## REMARKS

MARKED UP COPY SHOWING CHANGES

Fig. 1

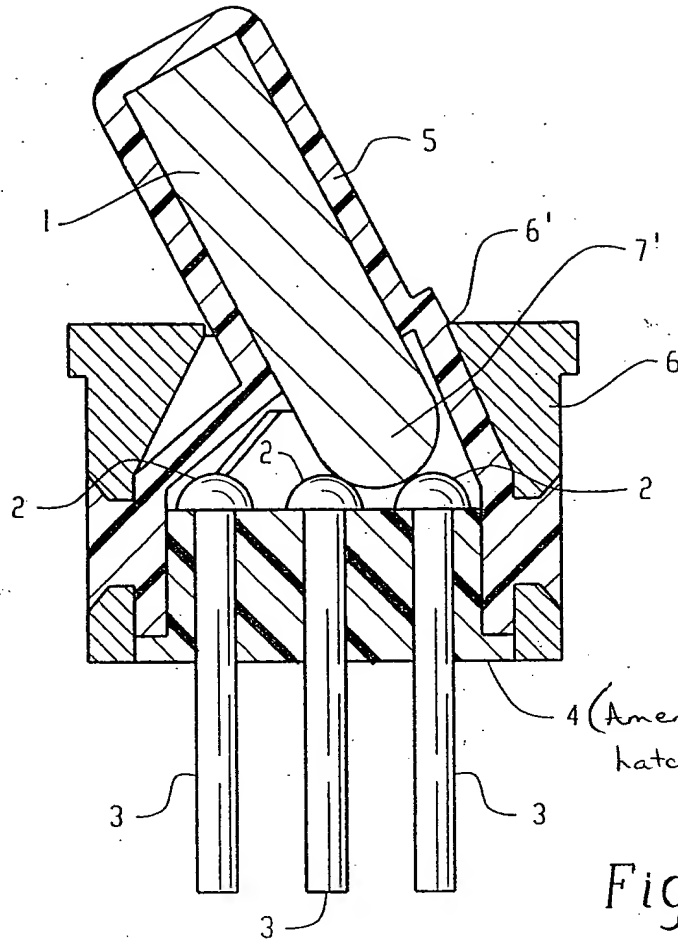
Regarding the objection to the drawings, applicants propose amending Figures 1, 3 and 5-7, as indicated in red ink, to properly cross-hatch the sectioned insulating materials. A set of corrected drawings is enclosed herewith, and the Examiner's approval of the proposed drawing changes is requested.
